Re: Yorkville Project Steel Sound Measurements

The purpose of this letter is to provide a response to the recent Soundscape Engineering comments.

Fig. 1 Detail at Generator Sound Barrier with Finer Grid Spacing

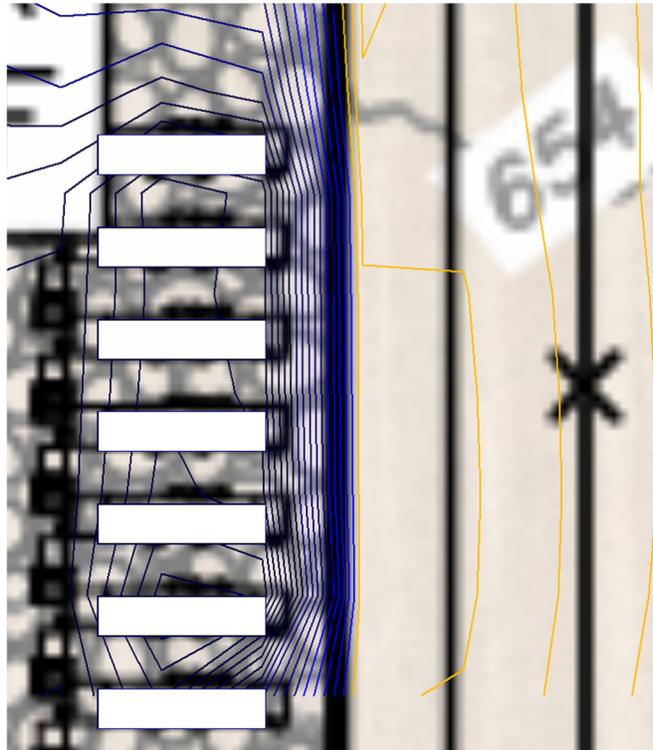
3. Comment: The report does not state how many generators were considered to be operating at one time and where they are located. In addition, the generators are shown in Table 4 to be 85 dBA at a distance of 23 feet, but the contours in Figures 1-3 show sound levels of no more than 70 dBA inside the generator enclosures. Also, there is no contour

discontinuity at the enclosure edge that we would expect to see with a sound barrier. Verify that the generator noise was included in the 3D model and indicate where they were located and how many were assumed to be operating at once.

Sound barriers are included and modeled correctly but sound level contour discontinuities may not be shown due to the large sound level grid spacing necessary with a project of this size. Fig. 1 below shows contours with finer grid spacing and correctly shows the discontinuities.
